# Intel<sup>®</sup> Celeron<sup>®</sup> Processor Specification Update

Release Date: May 2002

Document Number: 243748-045

**Figure 1 Celeron® on 0.13 Micron Processor 256K Platforms Workaround**

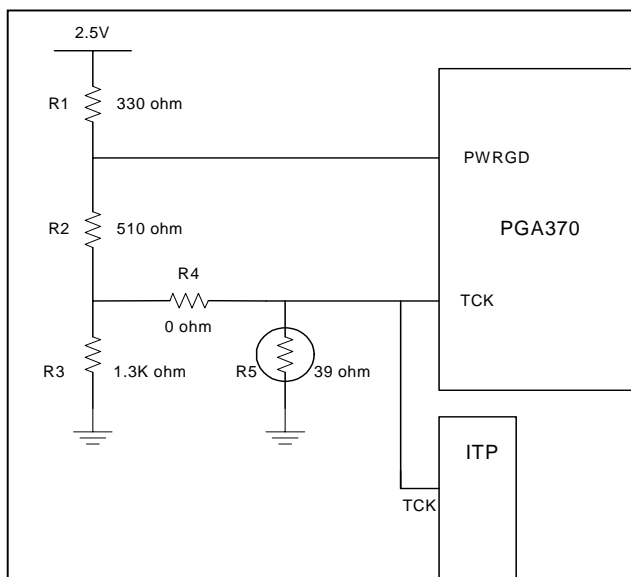
**Workaround:** To prevent the risk of power-on boot failures or catastrophic thermal failures, a platform workaround is required. The system must provide a rising edge on the TCK signal during the power-on sequence that meets all of the following requirements:

Please note, the example workaround circuits attached require circuit modification for ITP tools to function correctly. These modifications must remove the workaround circuitry from the platform and may cause systems to fail to boot. Review the accompanying notes with each workaround for ITP modification details. If the system fails to boot when using ITP, issuing the ITP 'Reset Target' command on failing systems will reset the system and provide a sufficient rising edge on the TCK pin to ensure proper system boot.

In addition, the example workaround circuits shown do not support production motherboard test methodologies that require the use of the processor JTAG/TAP port. Alternative workaround solutions must be found if such test capability is required.

For Production Boards:  
*Depopulate R5*
